**COVID-19 Recovery (Fast-Track Consenting) Act 2020 – QTT Response to RFI**

Thank you for your request for further information under section 22 of the COVID-19 Recovery (Fast-Track Consenting) Act 2020.

Figure 1 Proposed trail alignment (yellow) in vicinity of Tucker Beach Landfill (QLDC Reserve)

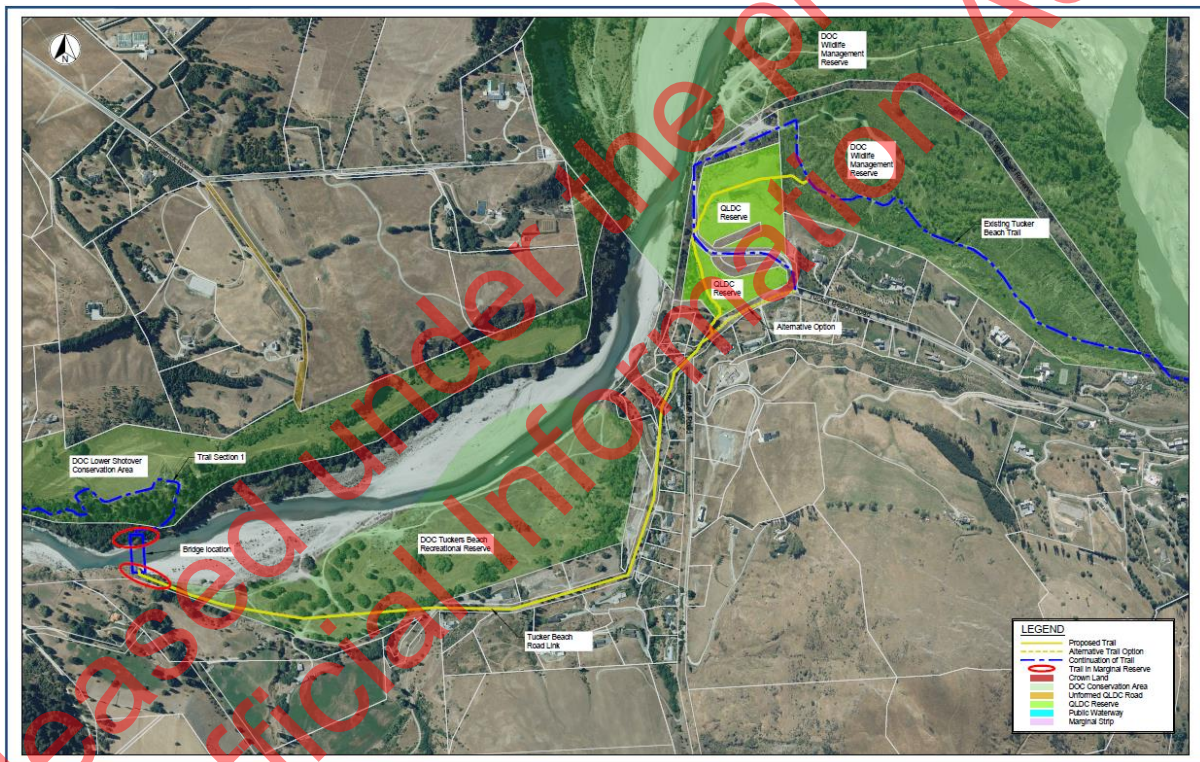
- **The location of the proposed works in relation to the Tucker Beach landfill**

The proposed works for the trail will cross the low-angle cap of the closed landfill to achieve a gradient suitable for a grade 2 cycle trail, as shown in Figure 1.

A Preliminary Site Investigation has been prepared for the site, which concludes that, provided the approximately 200mm clay cap over the landfill remains undisturbed, contaminants present within the landfill will remain encapsulated and no pathway will exist between the source of contaminants and the end-users of the trail.

Due to the gentle nature of the slope, the Engineering Feasibility Report prepared for the project considers that fill material can be placed (once vegetation is removed) directly on the current ground

level to form the trail base where ground levelling is required. No excavating of the cap is proposed. This will remove any negative impact on the cap of the landfill and will retain its integrity.

There is an alternative fall-back route which would not require crossing of the landfill and would use the existing gravel road which runs through the site (shown in dashed blue in Figure 1). However this route is circuitous, and would be slightly steeper than the desired Grade 2 gradient, so it is the less preferred option.

Figure 2: Impact on regional employment, Martin Jenkins

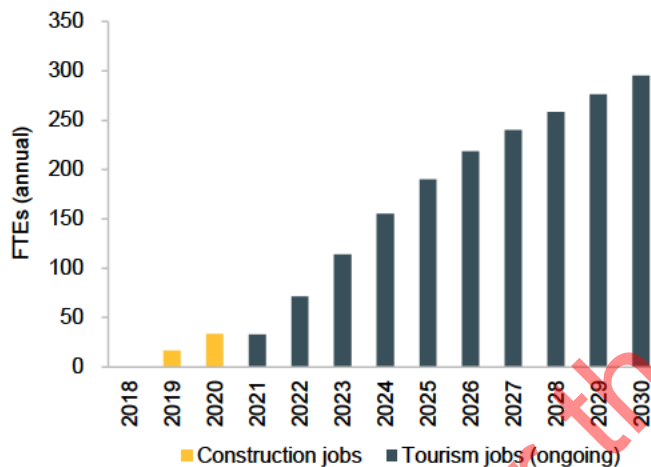
- Information, especially any expert reports, to support the estimates of employment created by the proposal.

Please refer to the attached *Queenstown Trails CBA summary\_QA approval* Martin Jenkins (page 8) and *Queenstown Trail Realignment Business Case – Final* Martin Jenkins (Page 34)

These expert reports estimate that between 25-28 full-time jobs will be created in each year of construction phase over 2-3 years, whilst up to 231 full-time jobs would be sustained annually as a result of trail related business associated within the first 10 years of operation of the trail.
